4.0 DESIGN DEVELOPMENT

4.9 RESPONSE TO PLANNING FEEDBACK

HOPWOOD HALL COLLEGE, MIDDLETON CAMPUS, ROCHDALE ROAD, MIDDLETON, M24 6XH
Application Nos 24/00548/LBC & 24/00547/FUL

SITE: Chapel at Hopwood Hall College, Greater Manchester

PROPOSED PLAN

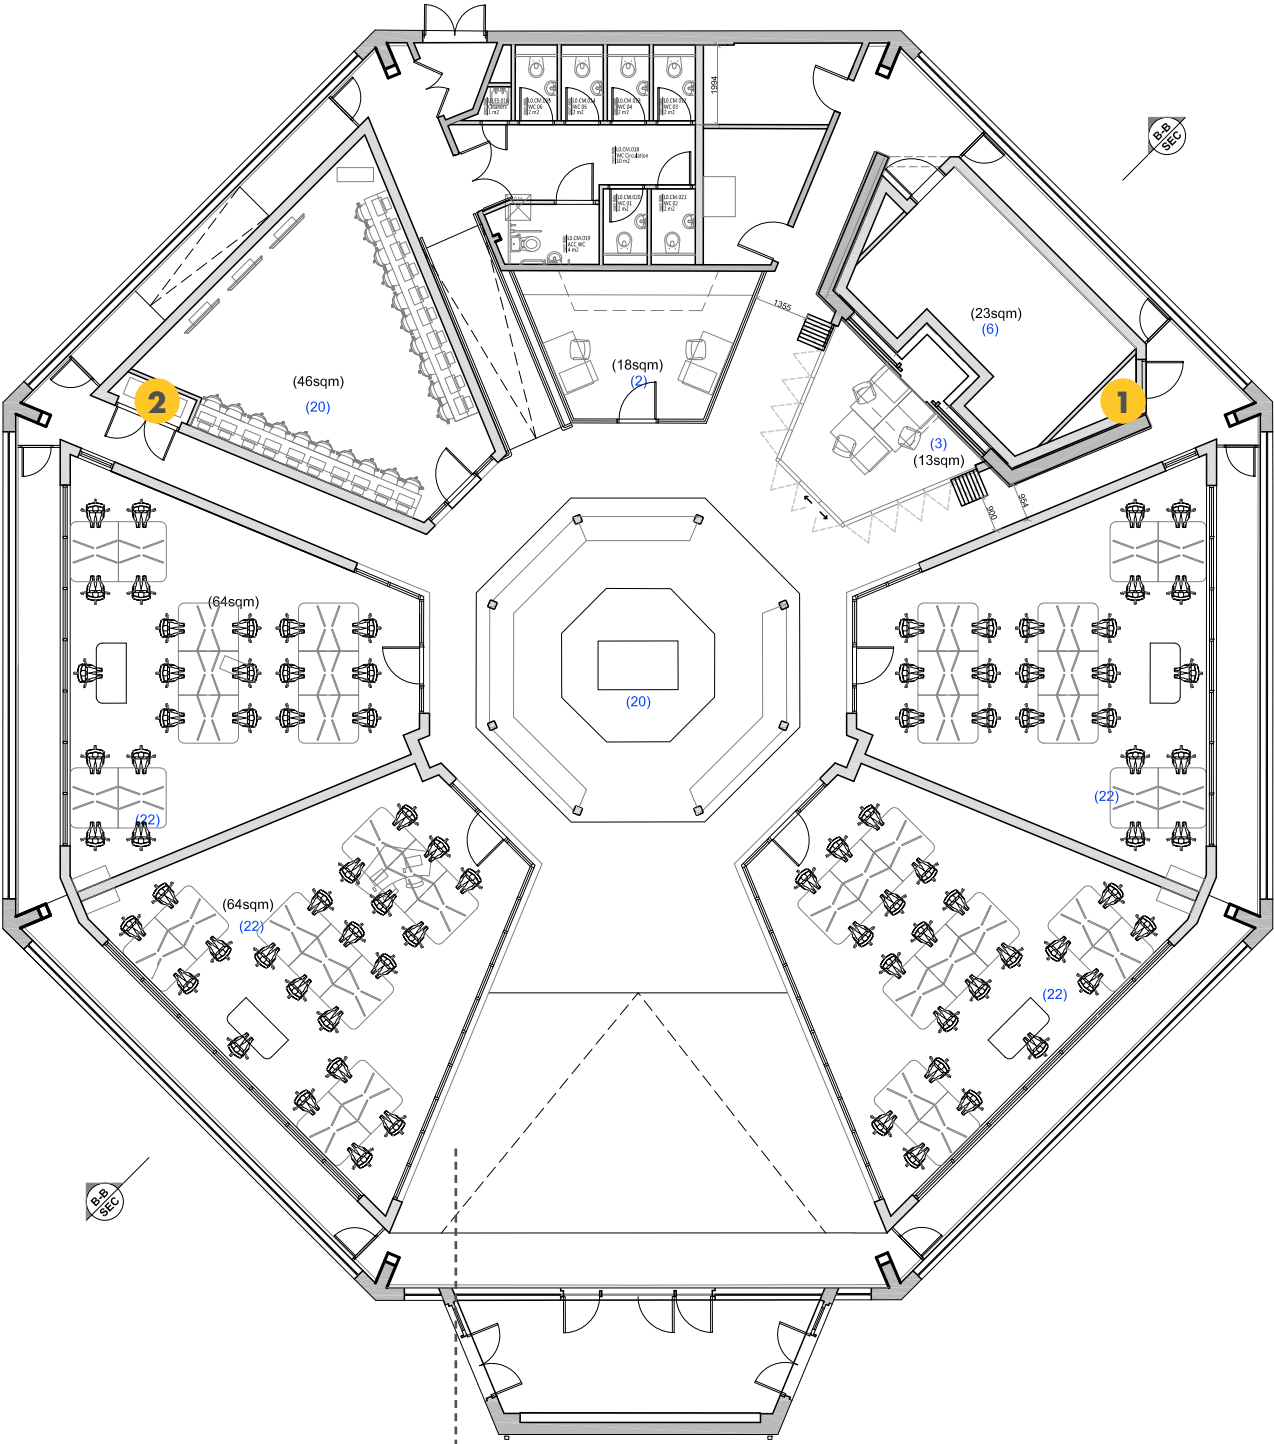
We would encourage the removal or reduction in size of classroom pods to either side of the main entrance to the chapel, to give a greater impression of the volume of the space and to prevent the sanctuary from becoming enclosed. The use of high-quality materials and finishes, with design drawing on the geometric shapes will be vital in sustaining the significance of the listed building.

Size of Classroom Pods

The size of the Classroom pods has been based upon the minimum areas required to facilitate a class size of 20 learners. This is based upon 20 desks each incorporating a PC with dual monitors which has been identified by the College as the minimum requirement for the successful delivery of the T-Levels curriculum. Guidance has been sought from a desk manufacturer in order to ensure that the classroom sizes are appropriate for the required equipment and detailed layouts are included within this document.

Whilst there is no statutory guidance for classroom sizes in Further Education Colleges, the latest EFA Schedule of Accommodation for Secondary Schools recommends an area of 62sqm for a standard ICT Classroom. The proposed classroom pods measure 64sqm. This is slightly larger than the EFA guidance but is considered reasonable given the unusual shape of the classrooms which have been designed in response to the geometry of the Chapel.

Position of New Stores

The new stores proposed adjoining the classroom pods either side of the entrance have been shown as re-positioned to help to open up the space as much as possible upon entering the Chapel.

- 1 Cleaner Store relocated
- 2 Laptop Store relocated

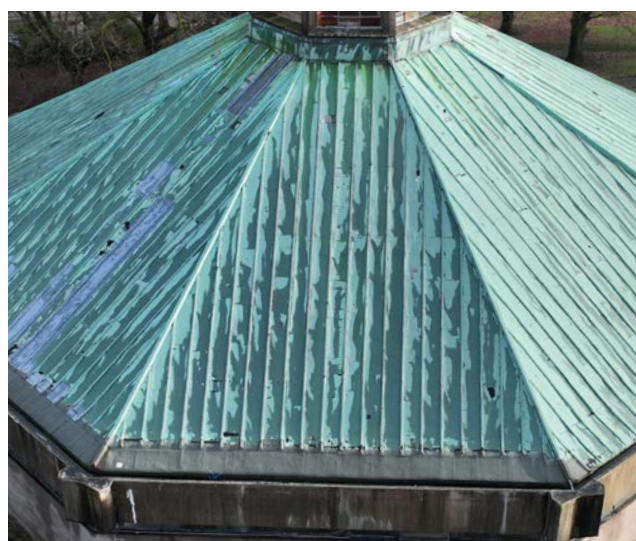
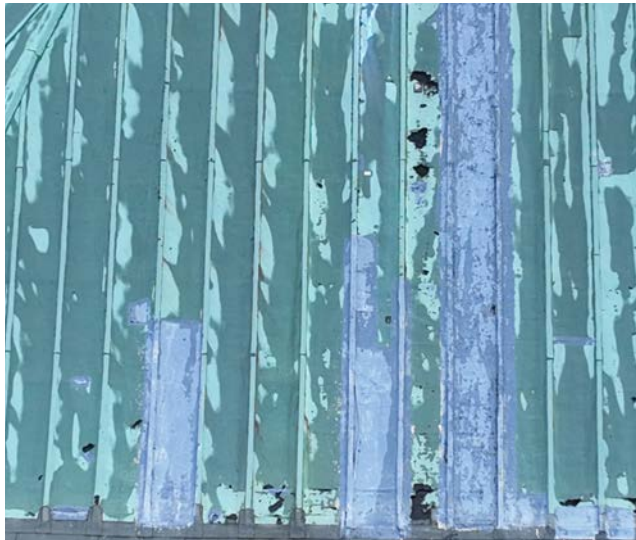
- New long term use for the Chapel is welcomed.
- Overall they consider that the proposals would result in less than substantial harm to its significance. This harm needs to be thoroughly justified and weighed against the public benefits arising from the scheme.
- Requested that we make changes to the scheme / provide further justification to satisfy Historic England Comments regarding the pods near the entrance
- Requested further information / justification for the removal and replacement of the copper roof and cladding

Our preference from a heritage and cost perspective would be to retain and repair the existing copper roof and cladding. However, it is proposed to replace the existing copper roof covering as this is considered to be beyond economic repair.

- *Reviewing the images we think the copper has passed its sell by date and would not be suitable for reuse.*
- *There are a number of failures and repairs over the sheets and this would indicate there would be little benefit in trying to save some sheets.*

- *Looking at the photo's there are dozens of patches all over the roof and there are also large areas that have been coated with liquid roofing products.*

- *This indicates to me that the copper is split in many places and has reached the end of its serviceable life. I can't see the laps so the copper may have been installed in far too long lengths and if I had to hazard a guess, I would saying the fixing method utilised does not allow for expansion.*

- *It is my opinion that the roof is in need of complete replacement.*

Consideration has been given to the retention of the existing copper and overlaying this using a new copper roof in order that the historic fabric is preserved. However, it is felt that the retention of the copper in it's current condition could potentially cover up ongoing issues with moisture ingress which would be detrimental to the building fabric going forwards.

A series of images are included opposite which illustrate the current condition of the roof, taken from Drone Survey footage in January 2024.

PROPOSED AXONOMETRIC VIEW

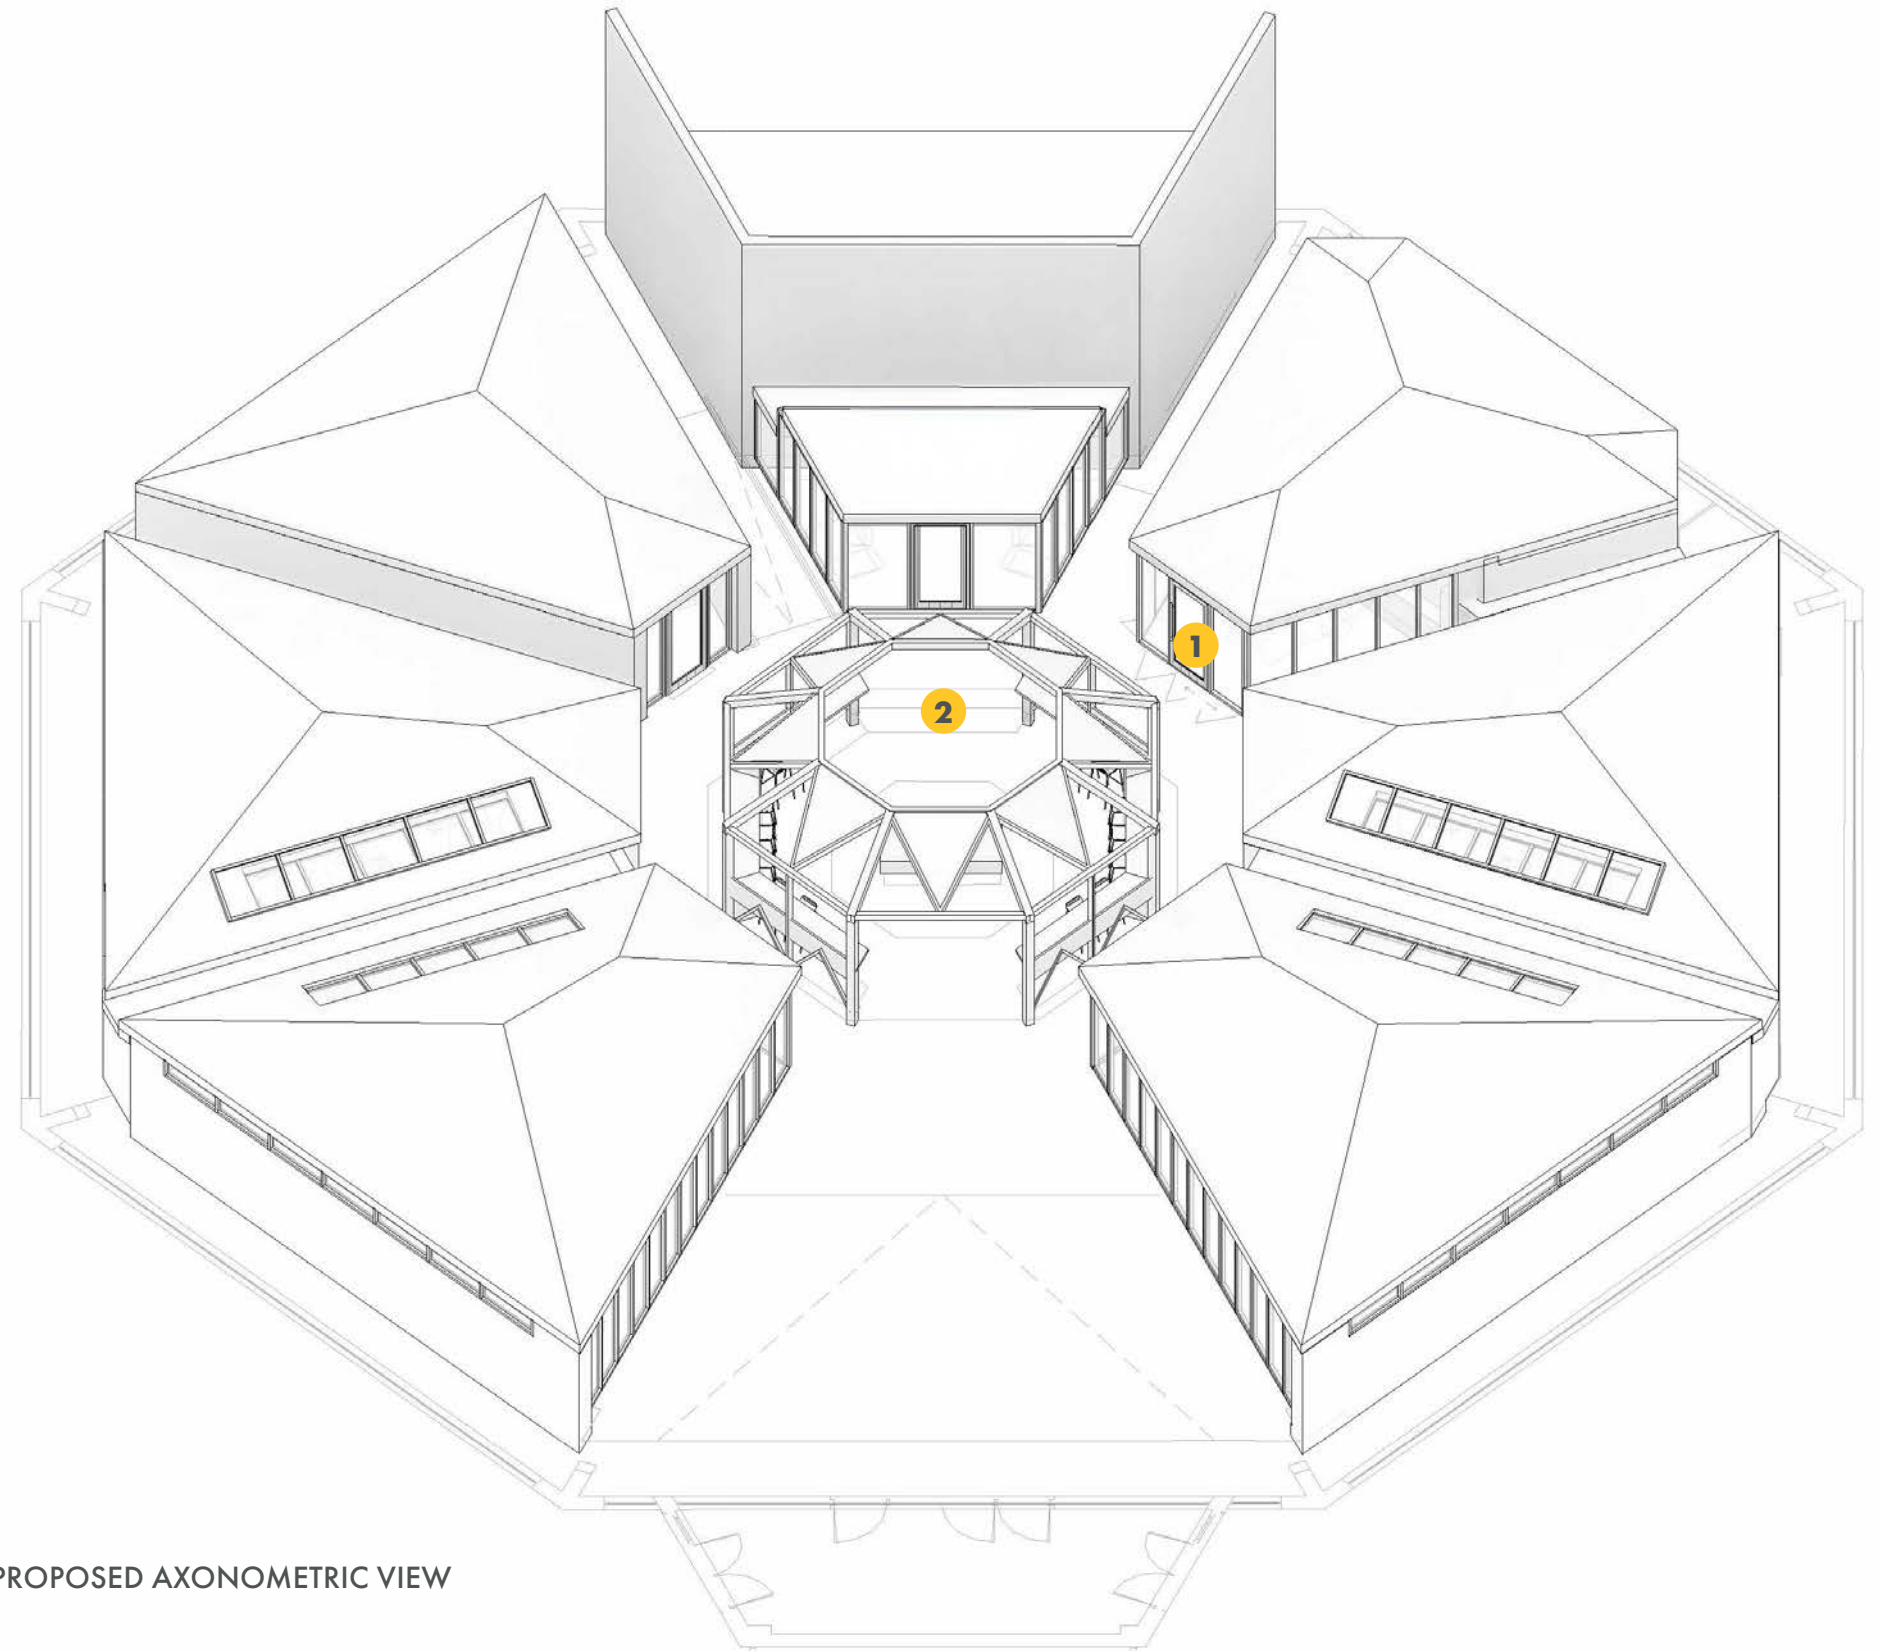
We do however have concerns about proposals to enclose the Blessed Sacrament chapel to create an immersive VR space and staff office. We feel that this chapel should be left unenclosed and remain

visible from the centre. The section of the new canopy around the altar could be opened up to that side too. This would allow the interesting existing canopy feature over the Blessed Sacrament altar to appear in its intended relationship with the main altar.

It is therefore proposed that this pod is retained but that the design is amended to increase views towards the Blessed Sacrament Chapel and to help preserve the relationship between this and the central altar. The following amendments are proposed:

1. Glazed walls to the office pod are amended to bi-folding doors system to allow these to be fully opened up to minimise the enclosure of the altar and canopy.

2. Sanctuary area amended to re-position the entrance into the Sanctuary area to sit opposite the side chapel - helping to reinforce the historic relationship between the central Altar and the Blessed Sacrament Chapel.

1 Bi-folding doors to Office to reduce the sense of enclosure to the Blessed Sacrament Chapel

2 Amendments to Sanctuary area to reinforce the relationship between the central altar and the Blessed Sacrament Chapel

PROPOSED PLAN

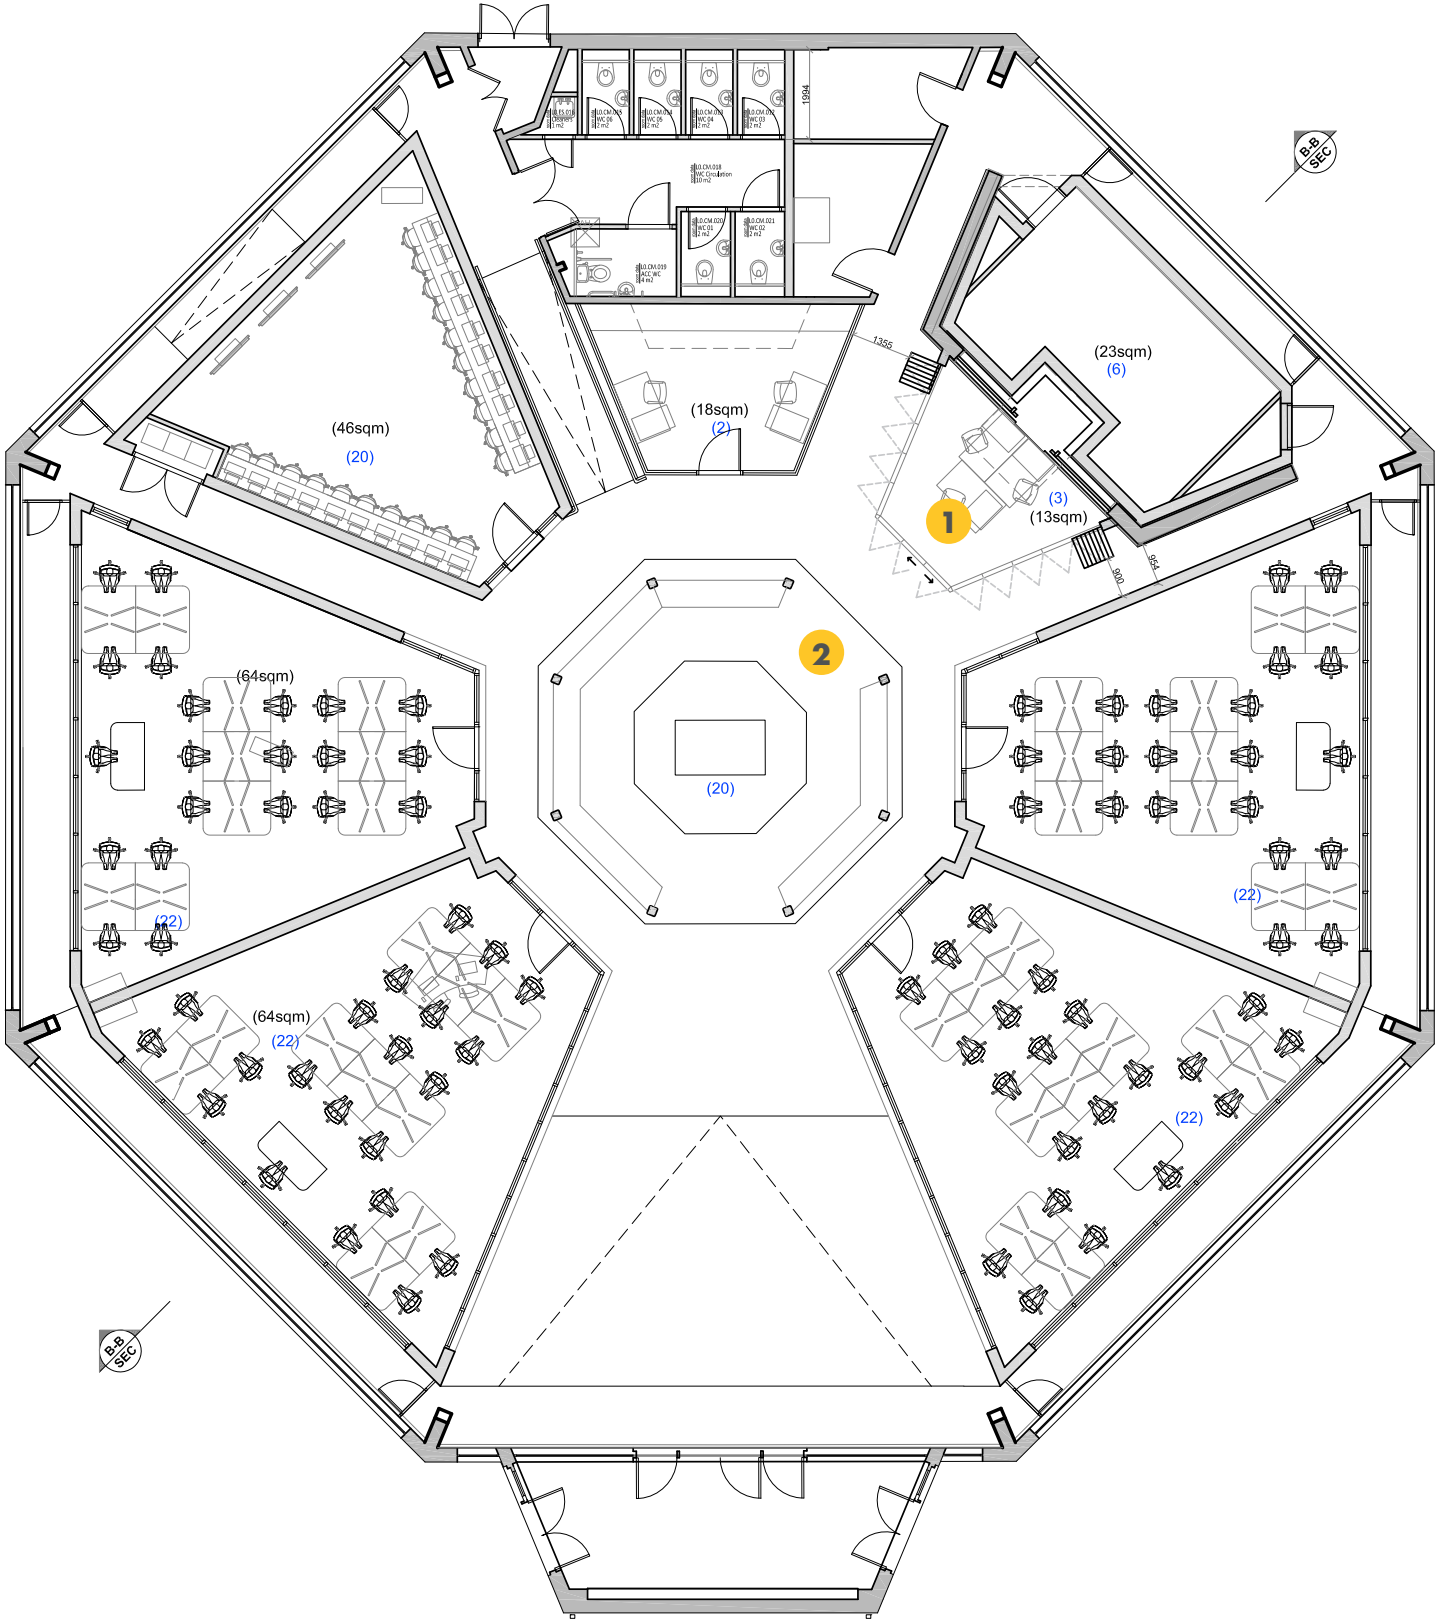
Committee members also discussed the proposed raising and covering over of the floor. Members appreciated the desire to achieve level access and had no objections to the proposal in principle. Members asked for reassurance however that the raised floor would be fixed in a way which does not cause damage to existing original floor finishes.

Raised Access Flooring

Detailed consideration has been given to the method of fixing the raised access flooring and advice has been sought from a number of raised access flooring manufacturers.

The majority of manufacturers will only provide a warranty for a floor which is either mechanically fixed or adhered to a suitable sub-floor.
